## Product Change Notification / CADA-13DJIO298

CCB 5156 Final Notice: Qualification of C194 as an additional lead frame material for selected PIC24F16Kxx, PIC24F32Kxx, PIC24FV16Kxx and PIC24FV32Kxx device families available in 48L UQFN (6x6x0.5mm) package.

**CCB 5156**  
**Pre and Post Change Summary**  
**PCN #: CADA-13DJIO298**

**EFTEC64T**

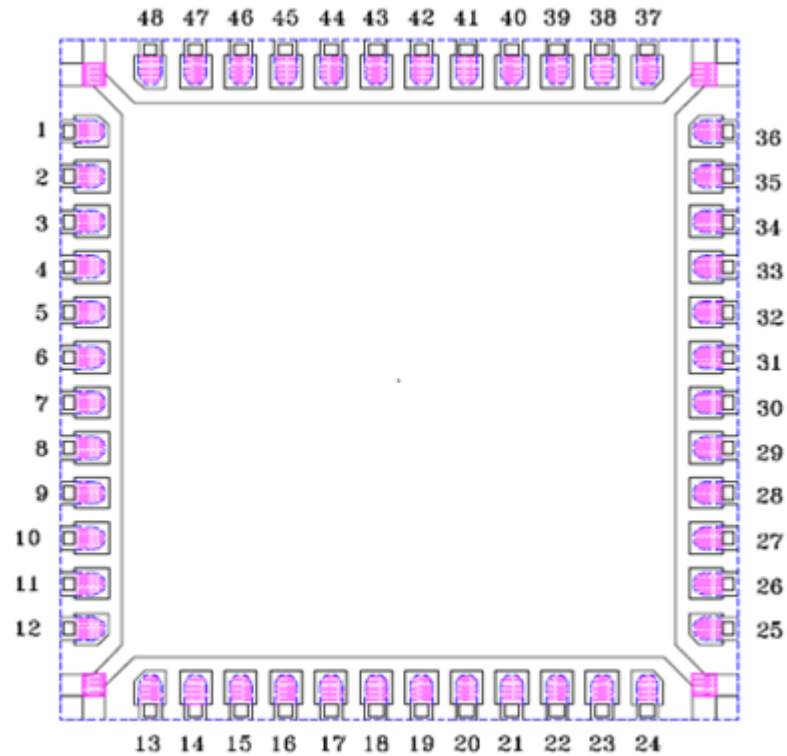
# LEAD FRAME COMPARISON

Lead frame Paddle Size

193x193 mil

**C194**

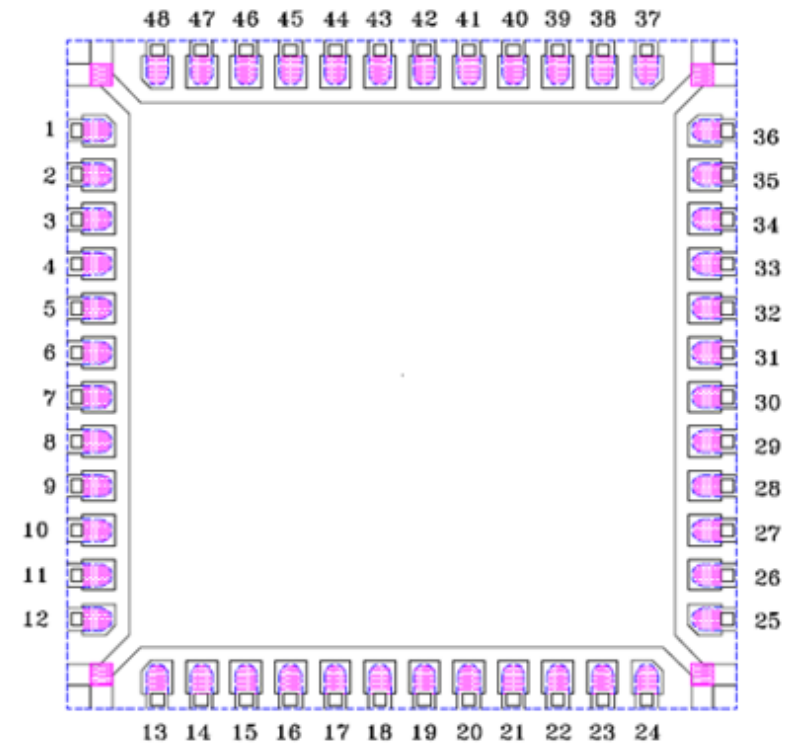
Lead frame Paddle Size

193x193 mil
